Re: Cooper Nuclear Station

The Commission has issued the enclosed Amendment No. 80 to Facility Operating License No. DPR-46 for the Cooper Nuclear Station. This amendment consists of changes to the Technical Specifications in response to your application dated April 30, 1982 and subsequent discussions between representatives of your staff and the NRC staff.

AMENDMENT TO FACILITY OPERATING LICENSE

Amendment No. 80
License No. DPR-46

Figure 3.11-2c 8x8R Fuel

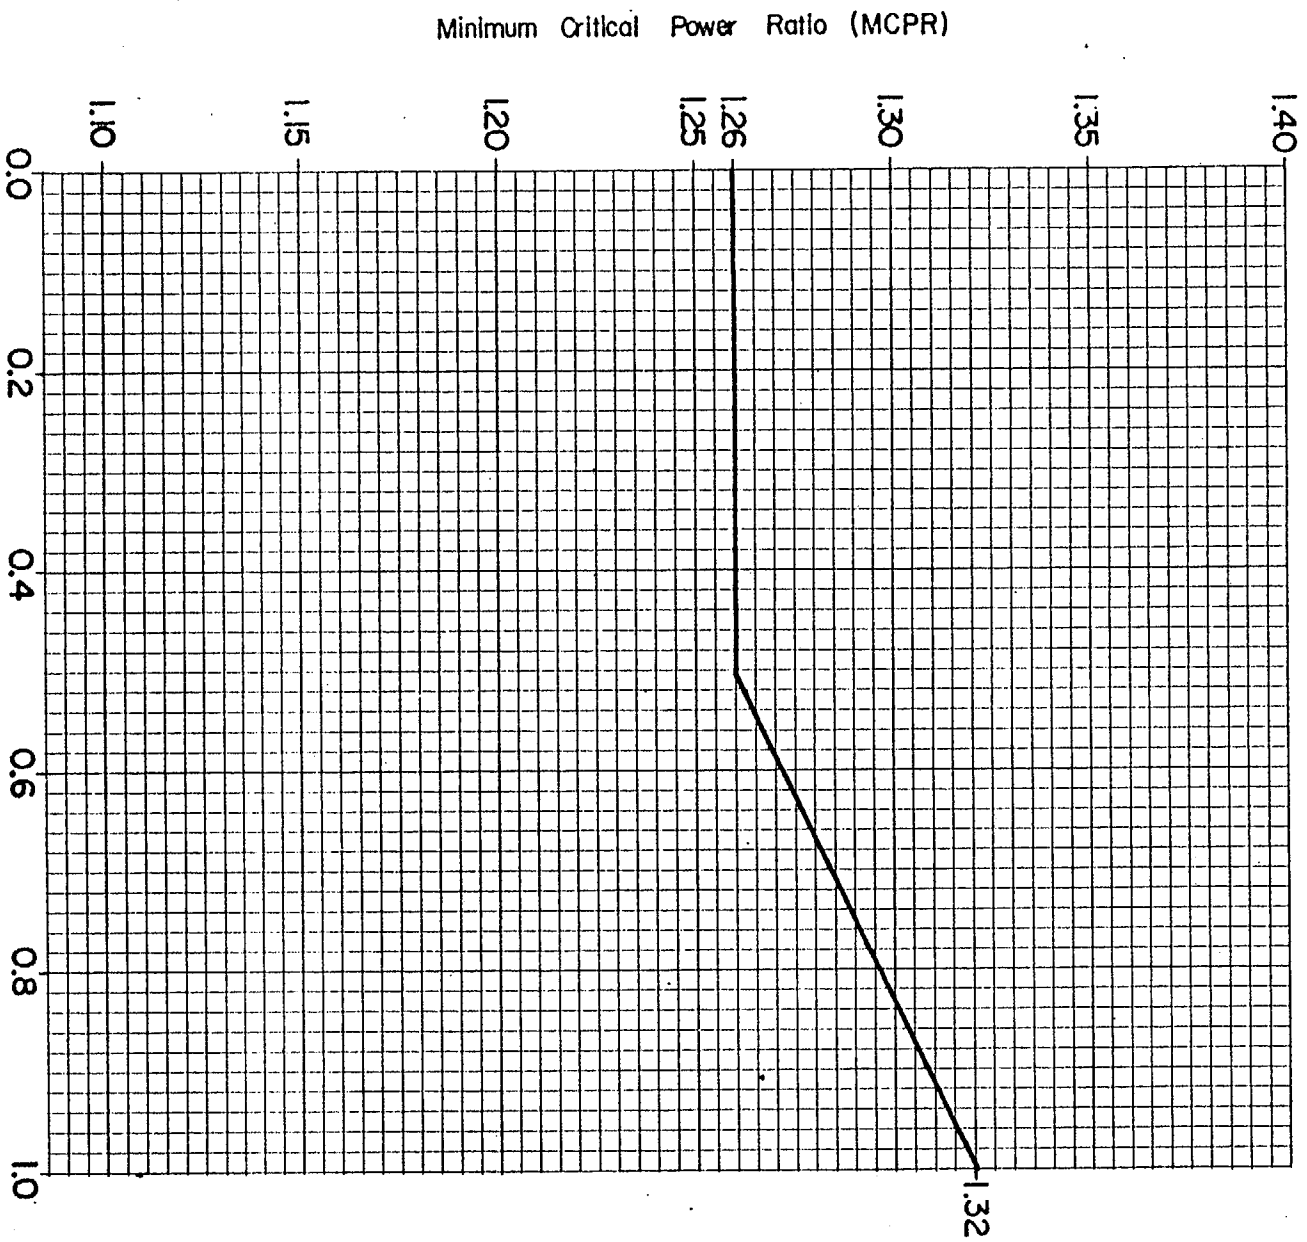
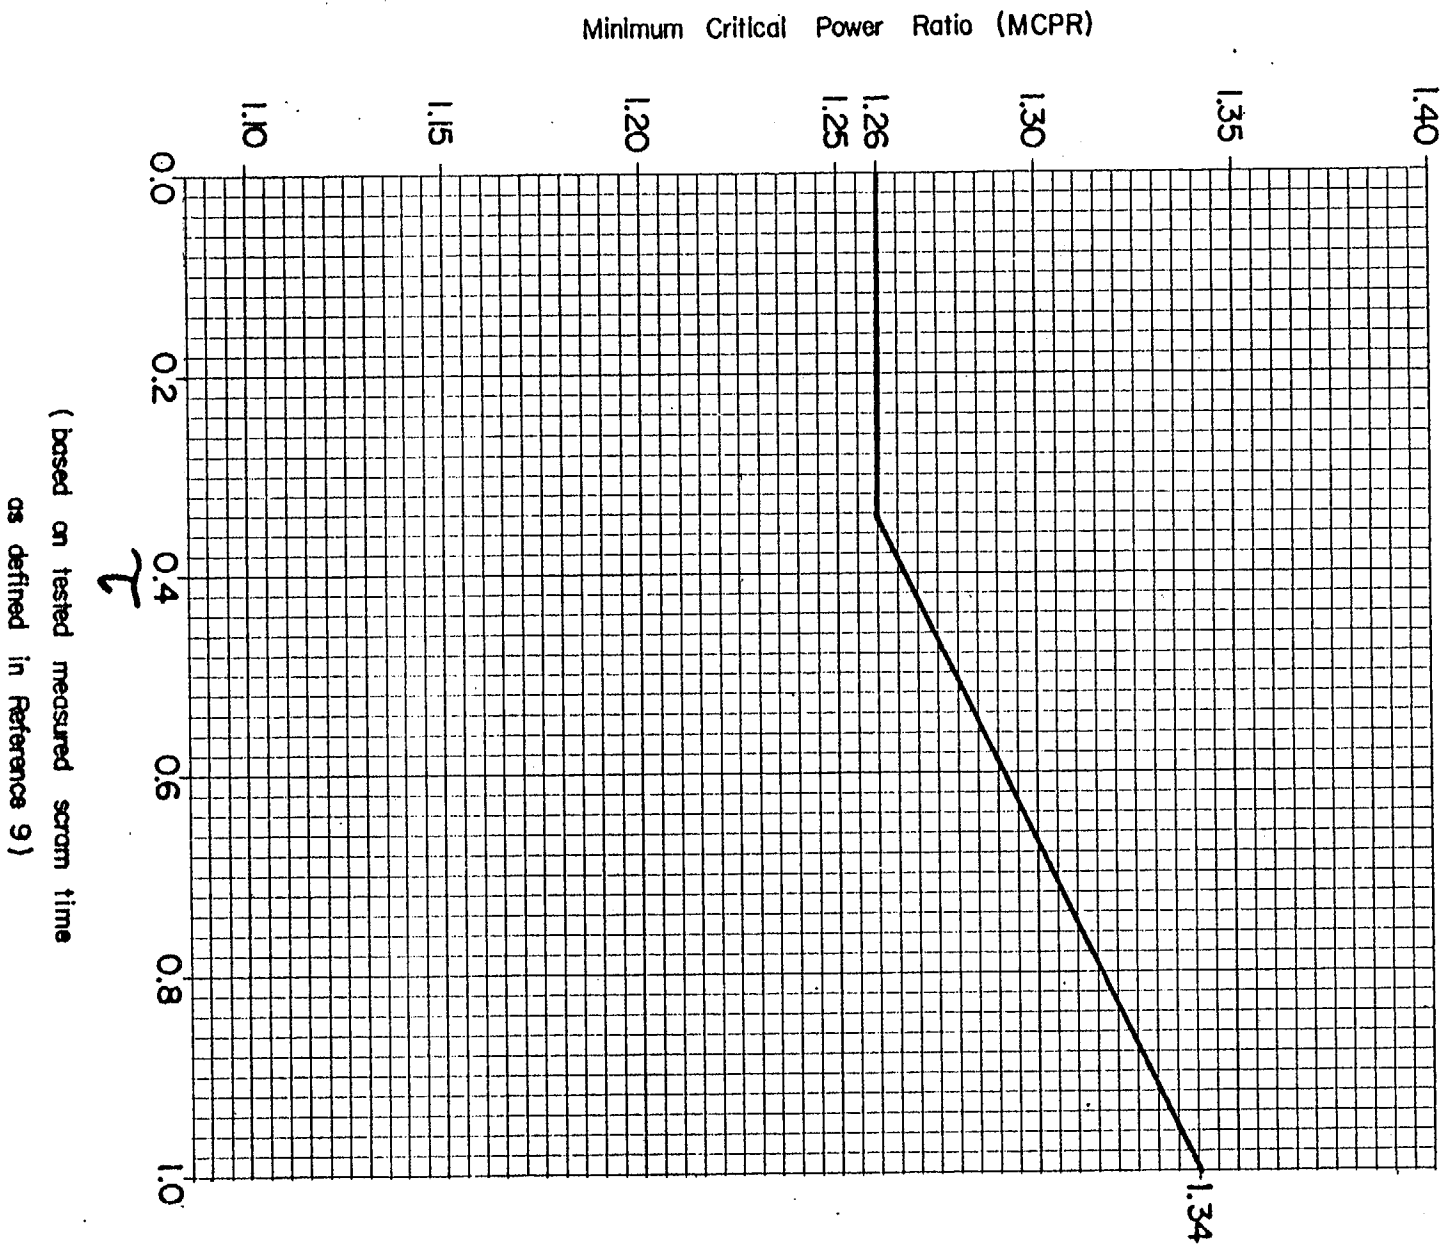
We have reviewed your changes to the MCPR values and RBM upscale trip level setting (identified as Revision 1) and since the proposed changes are bounded by your currently approved Technical Specifications, they are acceptable.

The limiting transient which determines the required steady state MCPR limit and thus yields the largest Δ CPR is discussed in Reference 5. When added to the safety limit MCPR of 1.07 the deterministic MCPR's are obtained. The required minimum operating limit MCPR's are determined by methods given in References 8 and 9.
